Comments

**Proposed Part 70 Air Operating Permit
Proposed Prevention of Significant Deterioration Permit
Environmental Assessment**

**South Louisiana Methanol Plant
St. James, Louisiana**

November 23, 2020

Figure 2: Methanol Complex site map provided with Application

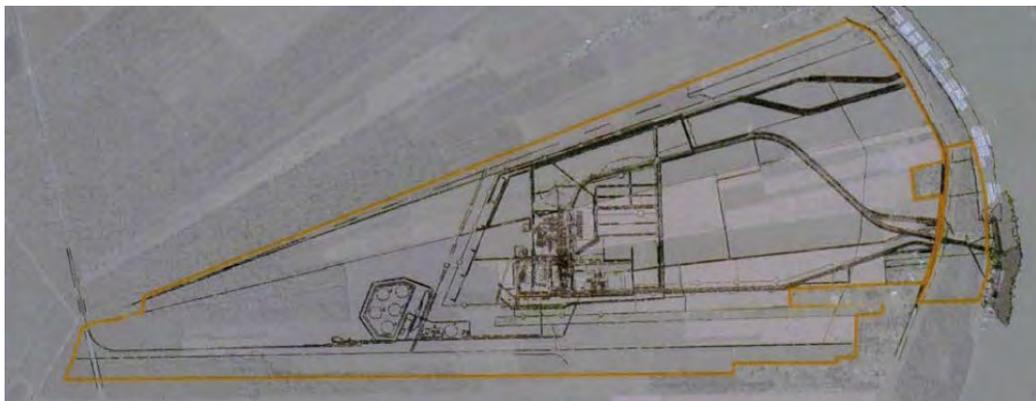
tanks, etc.). The Application contains only an illegible site map without labels, shown in the excerpt in Figure 2.

Because the proposed modifications include changes in locations for previously permitted sources, the plot plans submitted in support of previous permits are not longer valid. (See also Comment II.A.)

Figure 3: Emissions from IFR tanks depending on internal support and type of roof

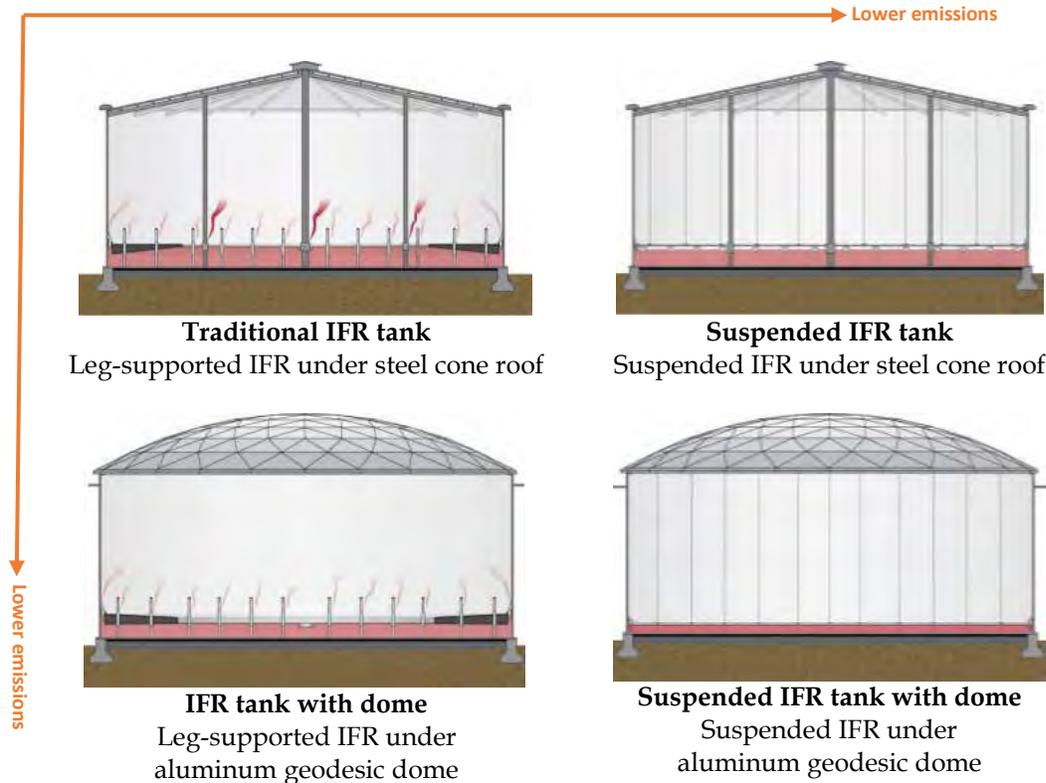
In general, IFR tanks with dome roofs have lower emissions than cone roofs and IFR tanks with suspended legs have lower emissions than those that are leg-supported, as illustrated in Figure 3.⁴⁸

Here, the BACT analysis fails to address the different types of IFR tanks and the draft permits, without any discussion, simply specify leg-supported IFR tanks rather than evaluating the control efficiency of the types of IFR support (leg-supported vs. suspended) or the types of tank roofs.

In sum, the BACT analysis for the Methanol Complex’s methanol storage tanks is substantially flawed and must be revised and establish emission limits based on a minimum 99% control efficiency.

Figure 4: Proximity of marine loading scrubber to residences and Welcome Park

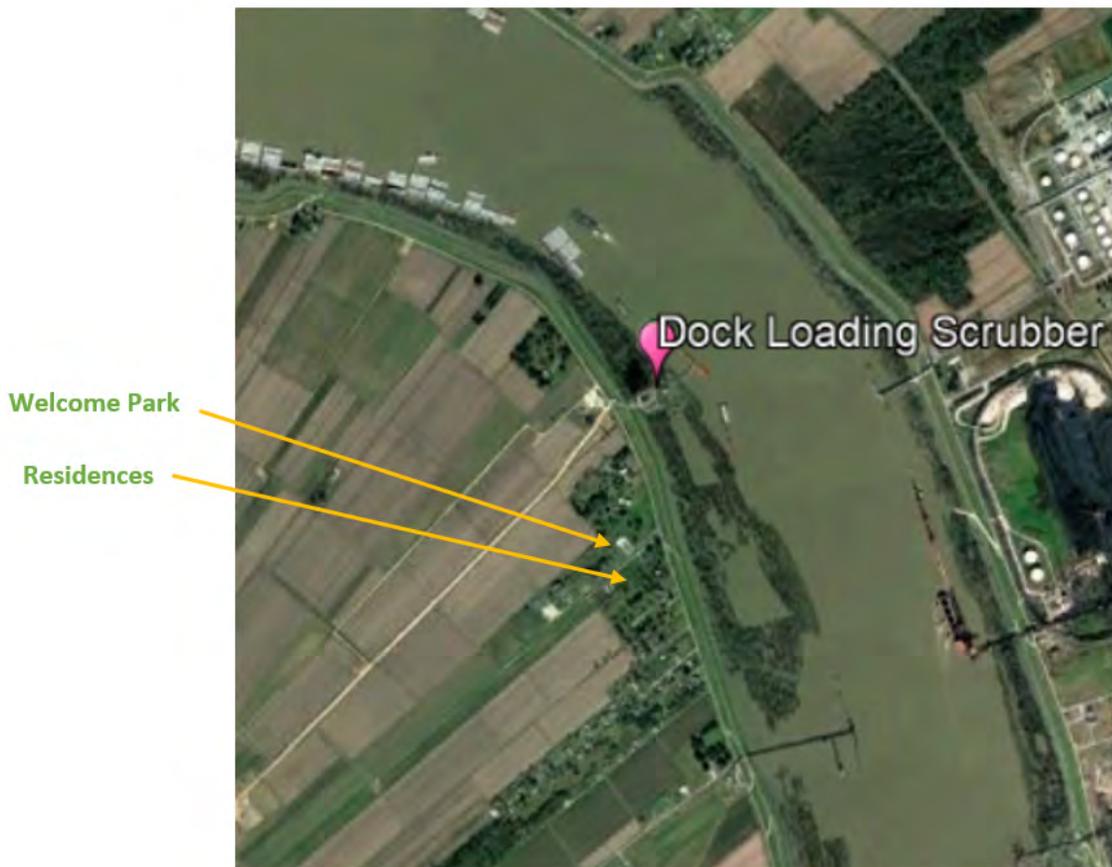
rates for the three terminal loading scrubbers. This is of particular concern for the marine loading scrubber, which would be located near residences and Welcome Park, as shown in Figure 4 below. (The distance to the nearest residential property is less than 750 feet and the distance to Welcome Park is about 1,700 feet.)

Figure 5: Methanol Complex site map

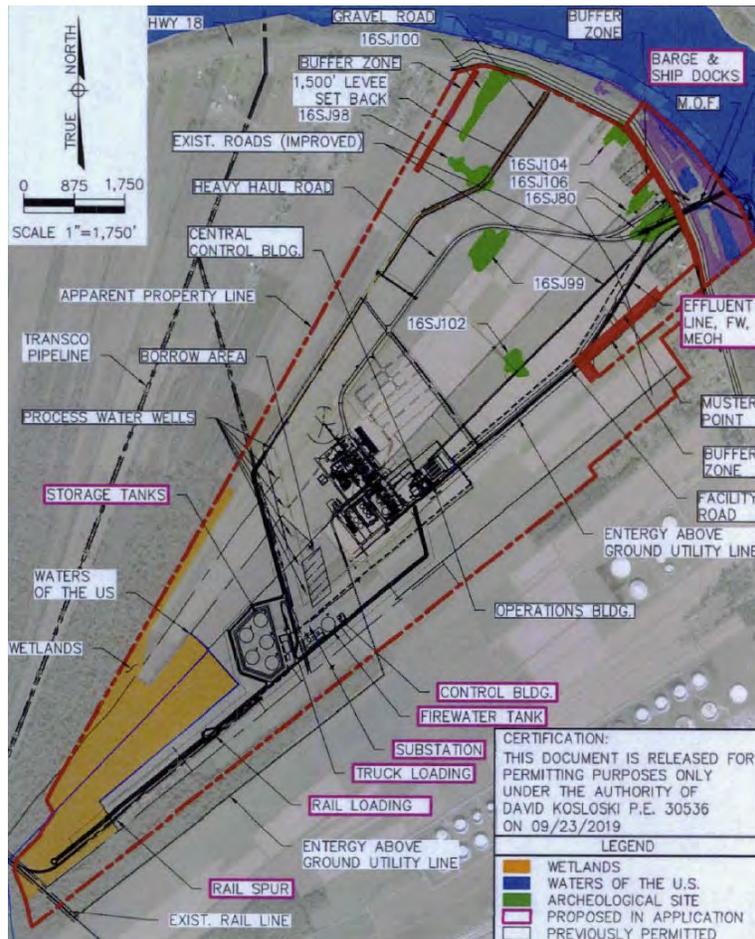
Second, the methanol production facility under review before LDEQ is not the same facility analyzed in the 2013 EAS and the 2016 EAS. The proposed extensive modifications to the facility’s current permits indicate a redesign of the methanol production train and its layout, which the 2019 EAS and the draft permits only cryptically acknowledge as “updates” to stack parameters and locations for previously permitted sources.⁶⁸ Nowhere in the record before the LDEQ does the Applicant acknowledge that the entire methanol production train has been completely redesigned. The only site maps submitted to LDEQ are not detailed enough make out any changes, as shown in Figure 2 (*see* Comment I.D.1 and Figure 5 below).

In sum, because construction of the methanol production plant has not begun and the facility has been completely redesigned, an EAS must address the environmental impacts of the entire Methanol Complex, instead of only looking at the proposed modifications. This requires a completely new alternatives analysis for the Methanol Complex and the 2019 EAS must be revised accordingly. Assuming, *arguendo*, that a new alternatives analysis for the Methanol Complex were not required, the alternatives analysis presented in the 2019 EAS is deeply flawed, as discussed in Comments II.A.1 through III.A.3 below.

Excerpted from: EDMS No. 10053134, pdf 245 (same as in EDMS No. 11181908 but more legible) (left) and CUP Application, *op. cit.*, Appx. G, Drainage Impact Study (right)

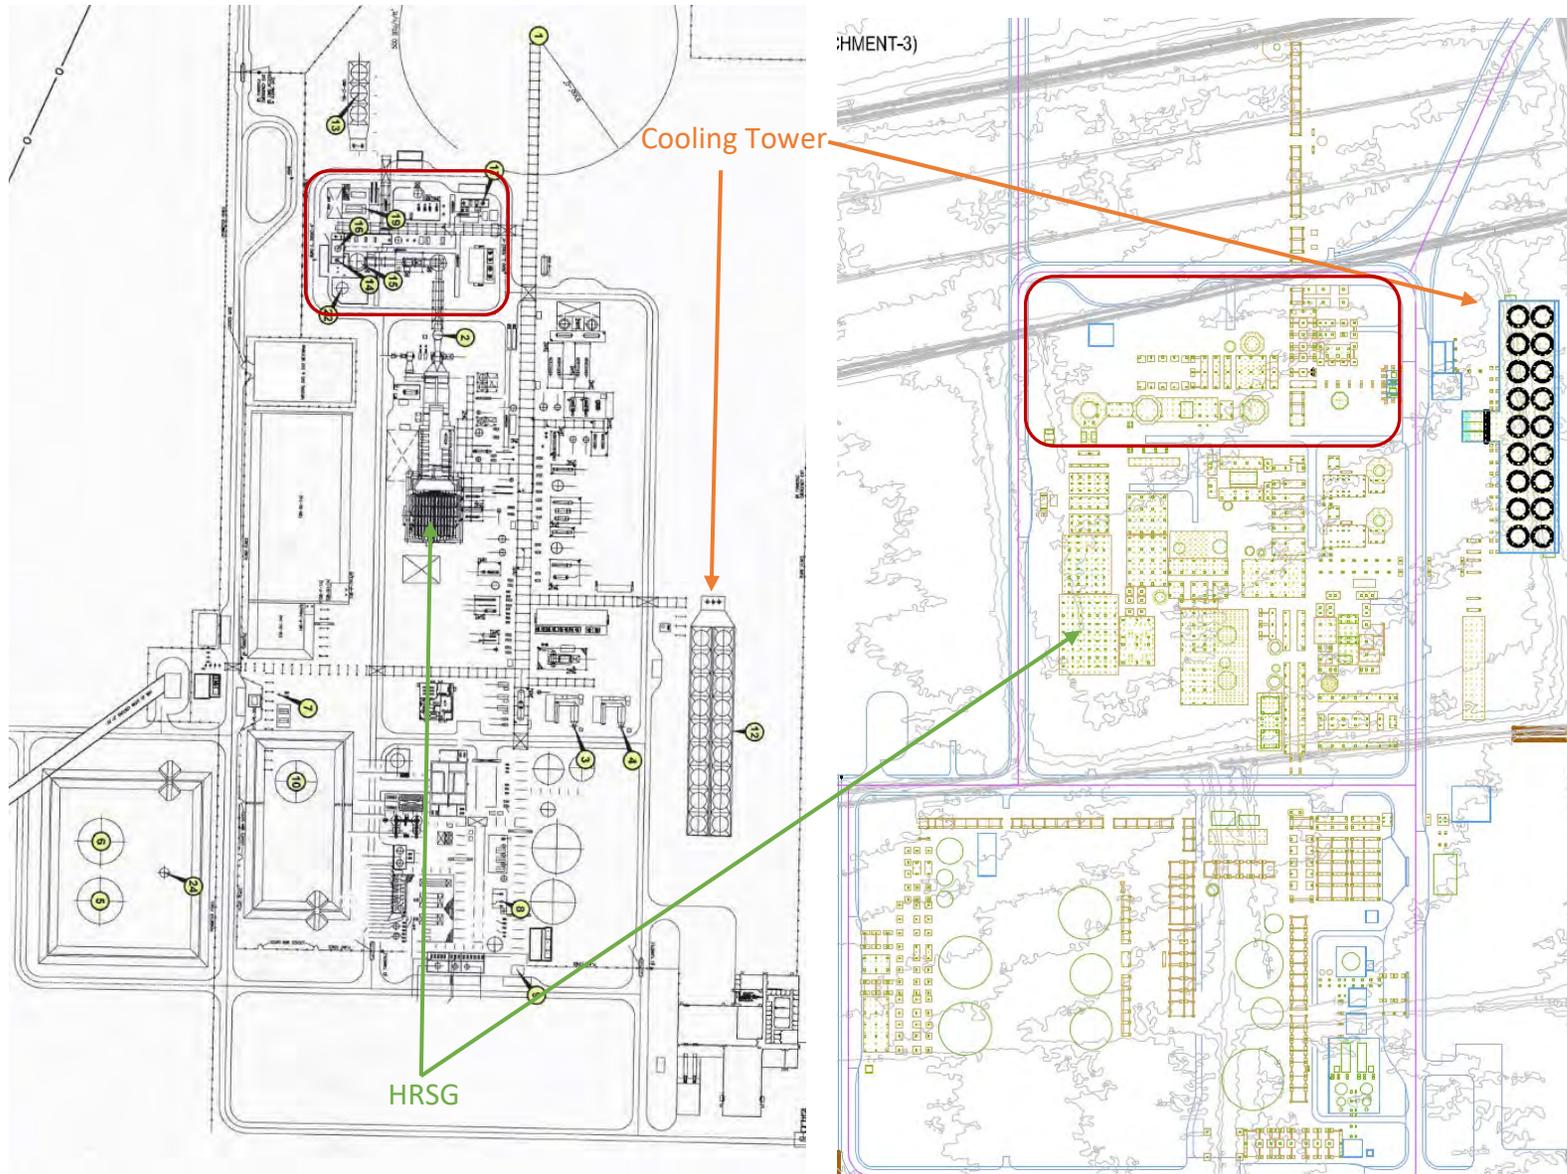
However, documents submitted by SLM to the Department of Natural Resources (“DNR”) and U.S. Army Corps of Engineers (“USACE”) to support an application for a Coastal Use Permit (“CUP”)⁶⁹ clearly show a complete redesign of the methanol production train. The excerpted site maps below show the methanol production train layout as currently permitted by LDEQ (left) and the foundations for the facility in the drainage plan submitted to DNR/USACE (right). Note, for example, the location of the heat recovery steam generator (“HRSG”) and the cooling tower in relation to the methanol synthesis area (red outline) and the arrangement of the internal roads encircling the various facility areas.

St. James Parish Project

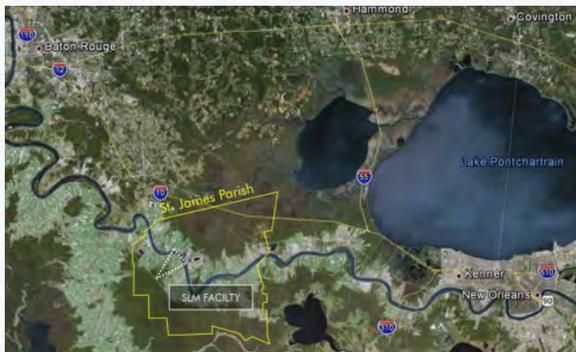
In fact, the Applicant ultimately plans to construct a facility that is five times larger than that (or more). Specifically, as shown in the excerpt below, SLM's website describes the currently proposed facility as "Train One" with a nameplate capacity production of ~2 million metric tons per year" and states that "[t]he St James site has sufficient space for at least five trains."⁷¹

Figure 7: Location of main facility access road and methanol pipeline to marine terminal in relation to Welcome Park

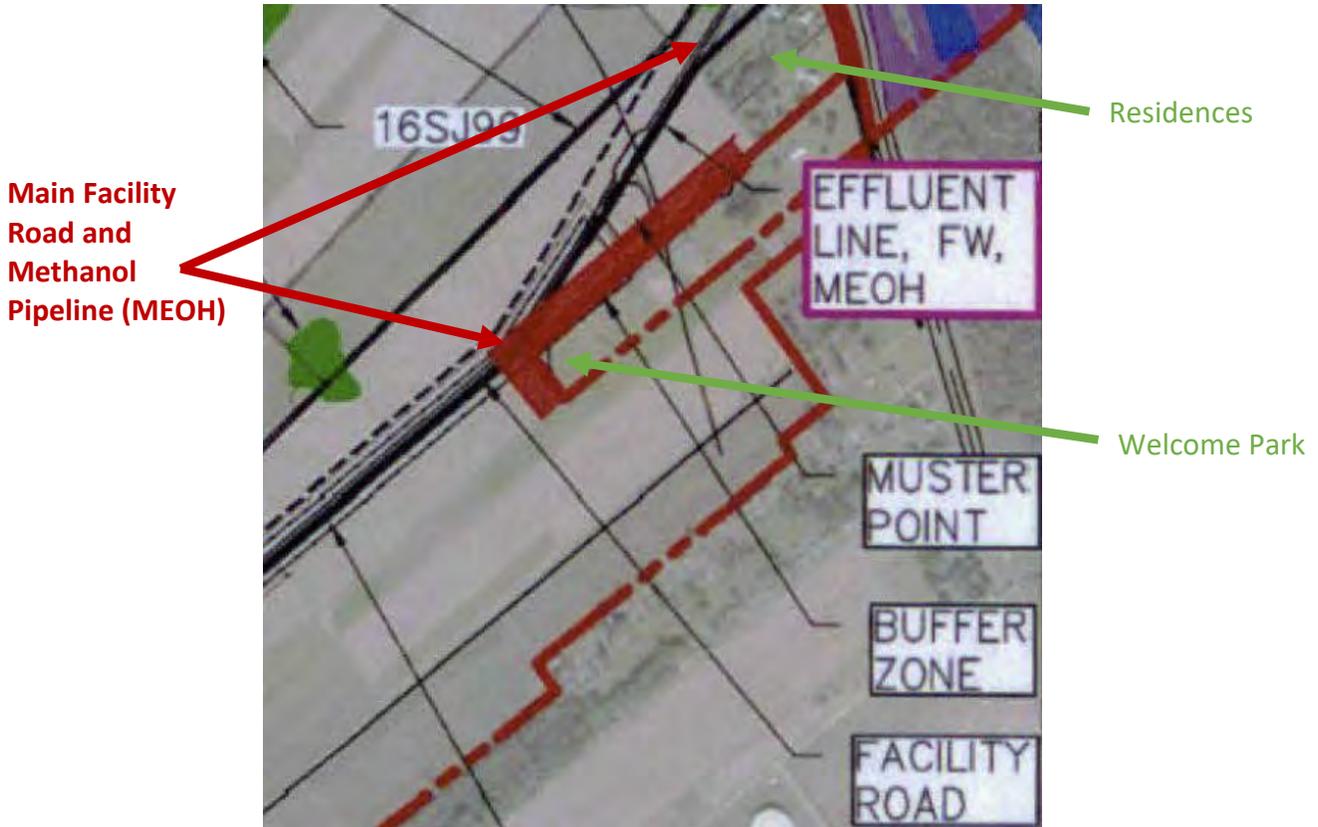
The 2019 EAS makes no mention of the fact that sections of the pipeline delivering methanol to the marine terminal and the main facility road would be located very close to Welcome Park (in fact they appear to run straight through the proposed 50-foot tree buffer zone along the north and west side of the park), as shown in Figure 7 below (*See* Comment II.B.2).

Second, tanker trucks loaded with methanol would travel on the main facility road from the truck loading terminal towards Highway 18.⁹⁶ A section of the main facility road towards the main facility entrance runs very close to Welcome Park, where children and adults recreate, and near residences, as shown in Figure 7 below.

In sum, the 2019 EAS, is severely deficient and must be revised to address health risks resulting from accidental methanol releases.
